Serial: RNP-RA/01-0164

H. B. ROBINSON STEAM ELECTRIC PLANT, UNIT NO. 2
DOCKET NO. 50-261/LICENSE NO. DPR-23

**REQUEST FOR TECHNICAL SPECIFICATION CHANGE TO
ELIMINATE REQUIREMENTS FOR THE POST-ACCIDENT SAMPLING SYSTEM**

5.5.3

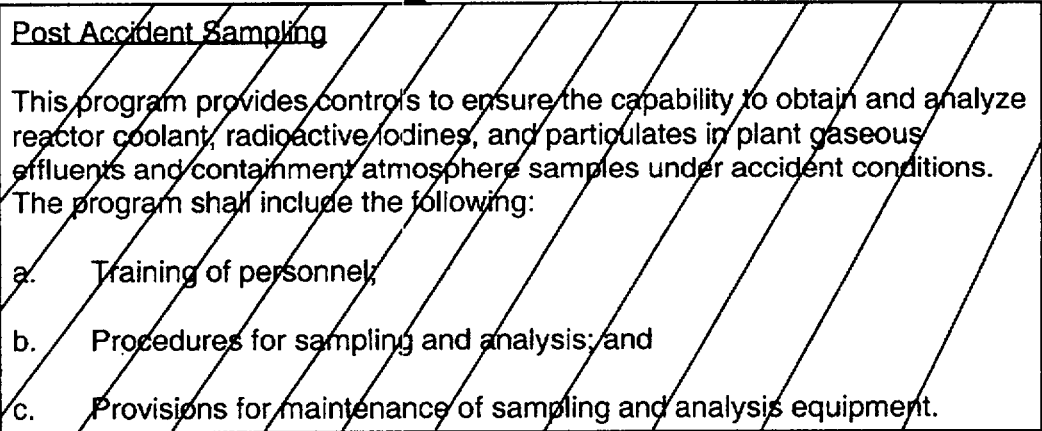
DELETED

Post Accident Sampling

This program provides controls to ensure the capability to obtain and analyze reactor coolant, radioactive iodines, and particulates in plant gaseous effluents and containment atmosphere samples under accident conditions. The program shall include the following:

- a. Training of personnel;
- b. Procedures for sampling and analysis; and
- c. Provisions for maintenance of sampling and analysis equipment.

5.5.3 DELETED
